Case File / Name: ASR-SR-9-2019 301 Hillsborough Street City of Raleigh
Development Services Department
One Exchange Plaza
Raleigh, NC 27602
(919) 996-2492
currentplanning@raleighnc.gov
www.raleighnc.gov

Development of a 1,85-acre tract zoned DX-20-SH into a 20-story Mixed Use Building with 583,972 SF of gross floor area (not including an additional 427,756 SF of parking deck). The structure will include an office tower, hotel tower, and residential tower. The breakdown of gross floor area by use includes: Office (291,645 SF), Hotel (127,432 SF), Residential (149,168 SF), and Restaurant (15,727 SF). The residential tower will include 136 dwelling units and the hotel tower will include 169 rooms/keys.

ALTERNATES, ETC: SPR-0170-2019: DSLC - Site Permitting Review/Major [Signature Set]

City Administration finds that this request, with the below conditions of approval being met, conforms to the Unified Development Ordinance. This approval is based on a preliminary plan dated July 23, 2019 by STEWART.

V1.01

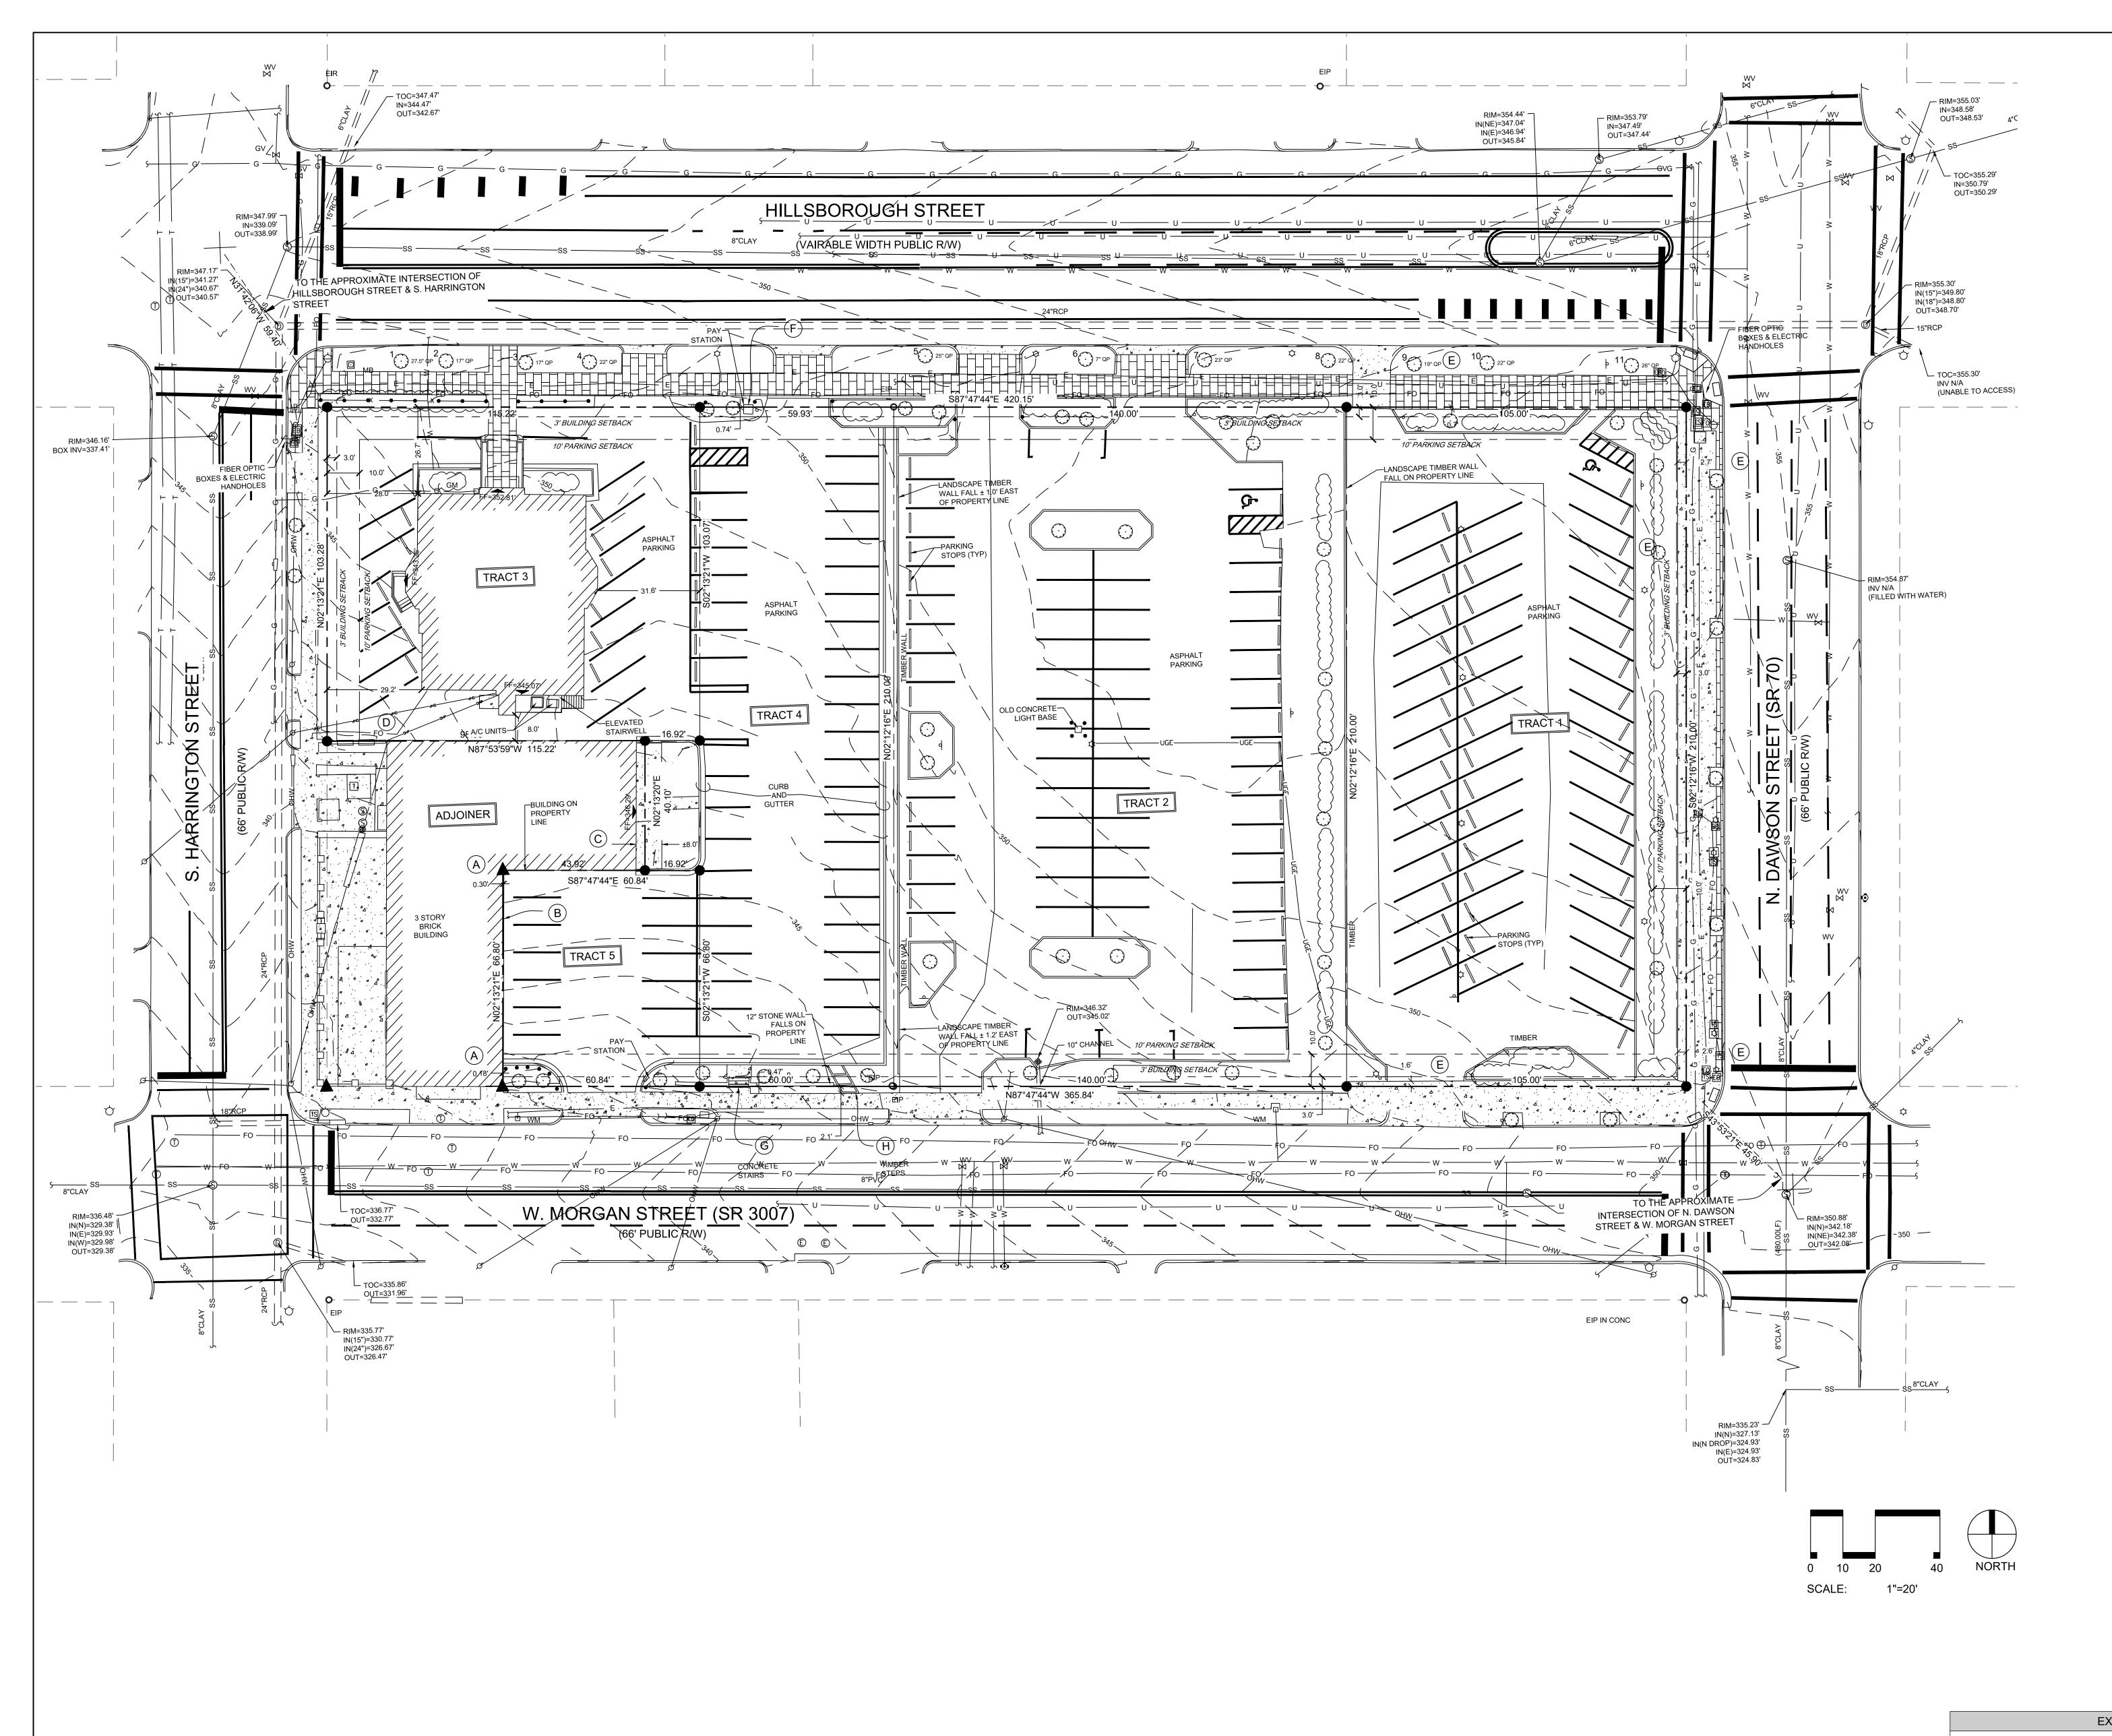
- Prior to issuance of building permits for Phase 1 (i.e. Office tower and parking structure) a
  recombination map is to be recorded, consistent with Sheet V1.01 of the approved Administrative
  Site Review plans (ASR-SR-9-2019). Prior to issuance of building permits for Phase 2 (i.e. Hotel
  tower, Residential towers, and parking structure) a recombination map is to be recorded, consistent
  with Sheet V1.02 of the approved Administrative Site Review plans (ASR-SR-9-2019).
- 2. A demolition permit shall be obtained.
- 3. Comply with all conditions of A-60-19, A-74-19, and AAD-10-19.
- 4. Provide fire flow analysis.
